4434 N 25th Street

Window replacement

COA approved with conditions July 12, 2021

Wooden Window

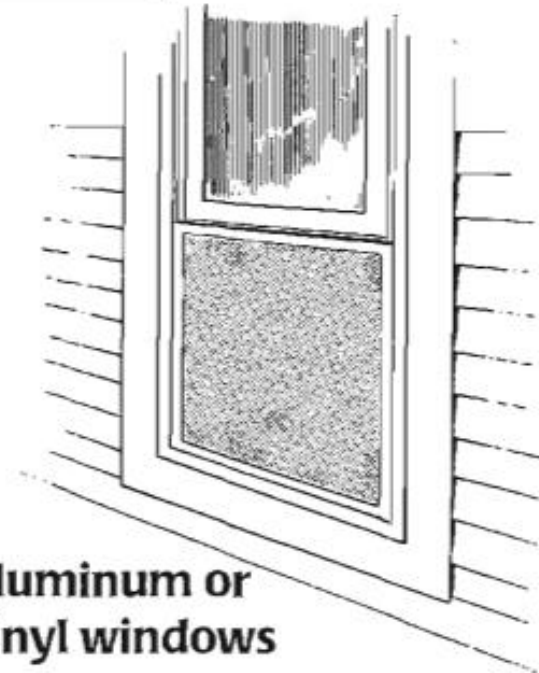
It is important to retain traditional wooden windows because they have distinct architectural character that can not be matched by most modern vinyl or metal replacement window units.
